1.0 Introduction

- 1.1 This technical note has been produced by the design and planning team in response to WSCC's letter of 6th November 2025, in their role as the LLFA, which is included in this technical note in [Appendix A](#).
- 1.2 This technical note responds to the LLFA's comments and provides additional information intended to support a clearer understanding of the site's opportunities, constraints, and the competing design and regulatory requirements that must be considered within the planning balance.
- 1.3 Each of the LLFA's comments are below in [blue](#), with the design and planning team's response following.

**DC/25/1327 Land East of Mousdell Close Rectory Lane Ashington RH20 3GS
Erection of 74 dwellings with associated access, parking, and landscaping.**

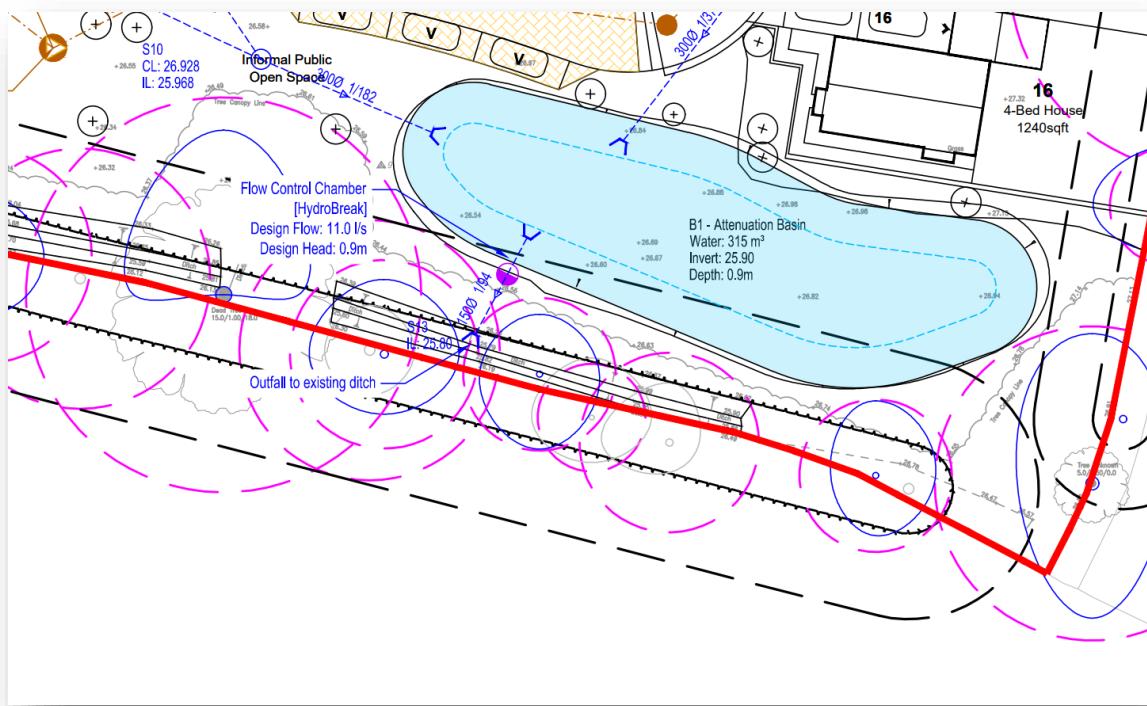
c) *Further information about the acceptability of the proposed discharge to the receiving watercourse needs to be submitted.* The new technical note states: “*The drainage ditch shown in the topographic survey is not that which is intended for the surface water discharge (hence why we are not addressing the comment that there appears to be a blockage in this ditch). The drainage ditch that is on the topographic survey is a drainage grip dug by the farmer to assist with field drainage. The actual discharge point will be the watercourse that is immediately to the south of the drainage grip on the boundary of the site (and which the landowner has riparian rights to).*” This statement appears to directly contradict the Drainage Strategy Plan (Drawing ref: 2504072-0501 P03) that was re-submitted as appendix K of the technical note. In that drawing the outfall from the proposed SuDS scheme is shown to discharge to a non-contiguous ditch within the site boundary and north of the tree line, which would appear to be the drainage grip mentioned above. (See excerpt below from the drainage strategy plan).

As discussed in my initial comments: The surface water drainage layout plan provides insufficient information about the receiving watercourse's: location,

nature, condition, hard bed levels, and connectivity with the wider network of watercourses. To remove our objection, we need to be satisfied that there is a viable destination for the site's discharge. Therefore, if the above statement from the technical note is correct (thus meaning the drainage strategy plan is erroneous), can the applicant please submit an amended drainage plan, detailing: The proposed discharge invert level, the existing silt levels, and the hard bed levels in the receiving watercourse. Additionally, two images of what I assume is the watercourse in question have been uploaded to the portal (dated 23rd October), these two images also raise concerns about the condition of the watercourse, as it appears to be severely obstructed with silt and debris). Can the applicant therefore please add a note to the amended drainage strategy plan confirming that routine the maintenance (in the form of removal of debris, de-siltation and re-grading) necessary to ensure the receiving watercourse is in a suitable condition to receive the discharge from the site, will be undertaken.

2.21 WSCC as the LLFA are correct on this matter and the incorrect outfall was shown on the plan. This has been corrected, and the outfall is now to the full drainage ditch. See [Appendix B](#).

- 2.22 As noted above, the drainage strategy plan was erroneous and has been corrected to show connection to this watercourse.
- 2.23 Regarding the observation that "*two images of what I assume is the watercourse in question have been uploaded to the portal (dated 23rd October), these two images also raise concerns about the condition of the watercourse, as it appears to be severely obstructed with silt and debris,*" we note that the images do not indicate a severe blockage, nor do they suggest that silt and debris present a significant issue.

Appendix B
Updated Drainage Strategy Layout

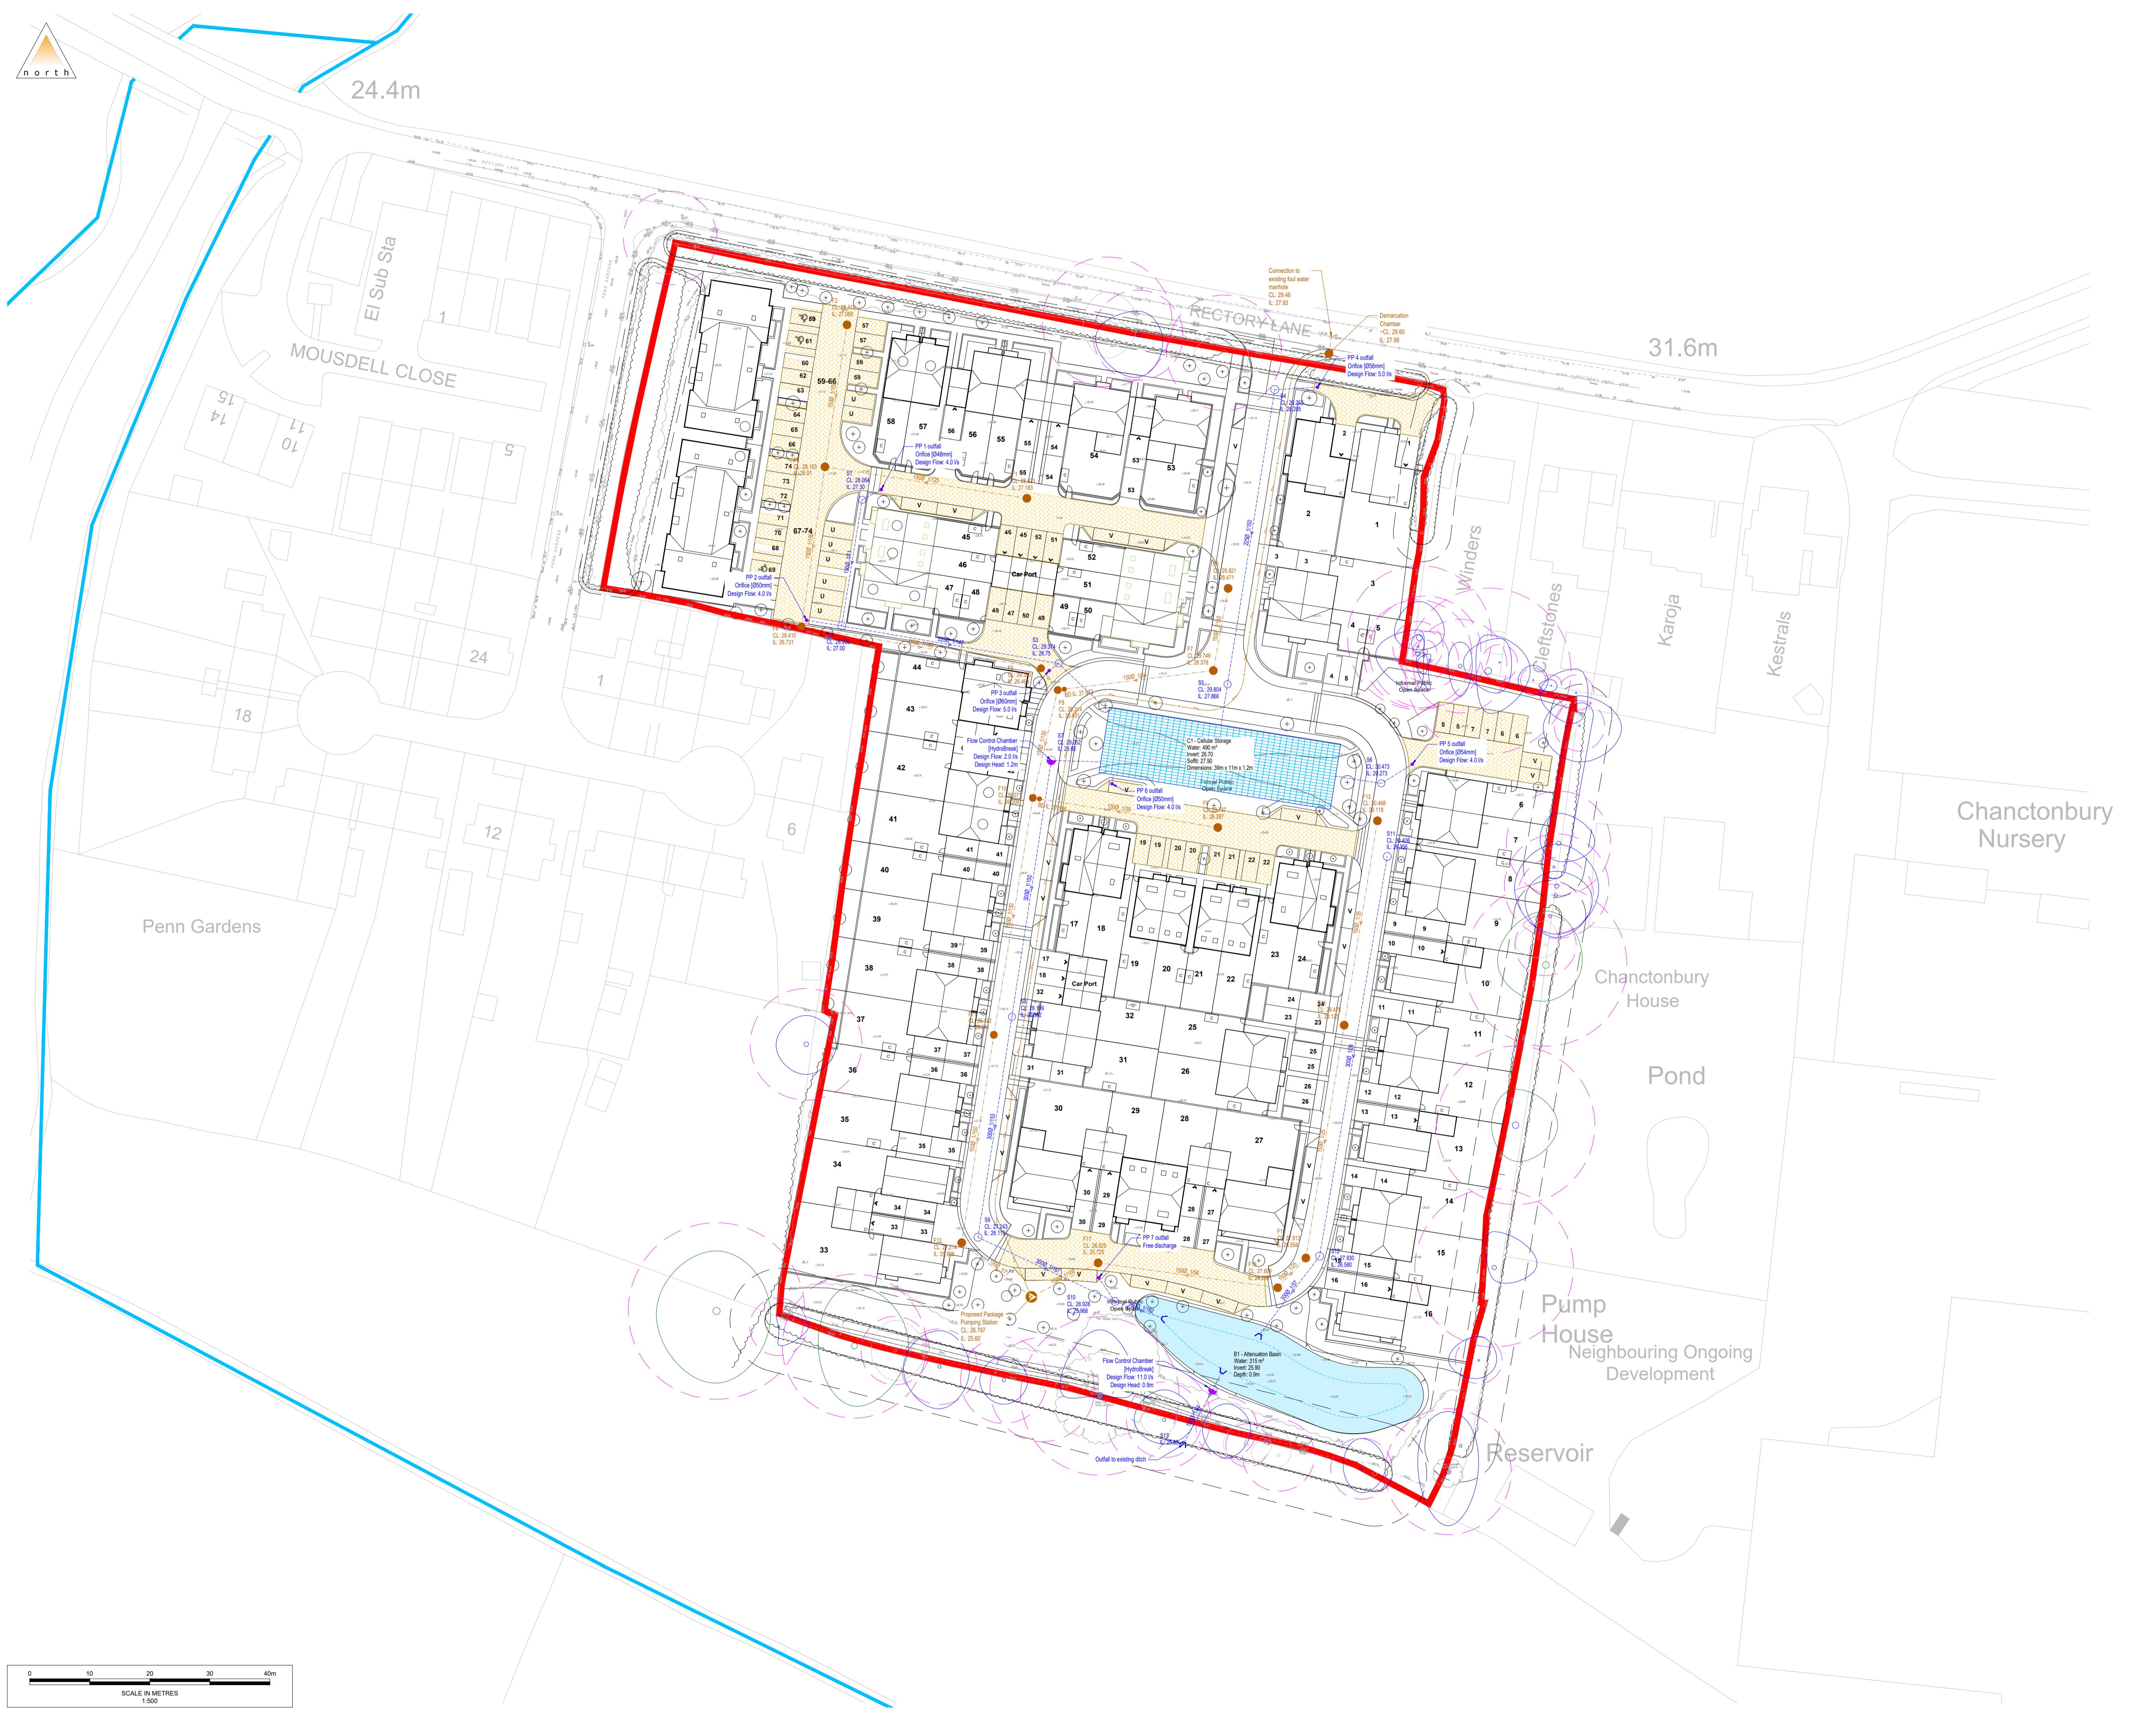
2.20 *"Further information about the acceptability of the proposed discharge to the receiving watercourse needs to be submitted. The new technical note states: "The drainage ditch shown in the topographic survey is not that which is intended for the surface water discharge (hence why we are not addressing the comment that there appears to be a blockage in this ditch). The drainage ditch that is on the topographic survey is a drainage grip dug by the farmer to assist with field drainage. The actual discharge point will be the watercourse that is immediately to the south of the drainage grip on the boundary of the site (and which the landowner has riparian rights to)." This statement appears to directly contradict the Drainage Strategy Plan (Drawing ref: 2504072-0501 P03) that was re-submitted as appendix K of the technical note. In that drawing the outfall from the proposed SuDS scheme is shown to discharge to a non-contiguous ditch within the site boundary and north of the tree line, which would appear to be the drainage grip mentioned above.*

As discussed in my initial comments: The surface water drainage layout plan provides insufficient information about the receiving watercourse's: location, nature, condition, hard bed levels, and connectivity with the wider network of watercourses. To remove our objection, we need to be satisfied that there is a viable destination for the site's discharge. Therefore, if the above statement from the technical note is correct (thus meaning the drainage strategy plan is erroneous), can the applicant please submit an amended drainage plan, detailing: The proposed discharge invert level, the existing silt levels, and the hard bed levels in the receiving watercourse. Additionally, two images of what I assume is the watercourse in question have been uploaded to the portal (dated 23rd October), these two images also raise concerns about the condition of the watercourse, as it appears to be severely obstructed with silt and debris). Can the applicant therefore please add a note to the amended drainage strategy plan confirming that routine the maintenance (in the form of removal of debris, de-siltation and re-grading) necessary to ensure the receiving watercourse is in a suitable condition to receive the discharge from the site, will be undertaken.

The location and nature of the watercourse outfall are displayed in the picture on the next page, which was provided in the previous Technical Note. The watercourse is below site level and can be reached by gravity, so absolute levels are not determinative, and we feel that these do not need to be proven at this stage.
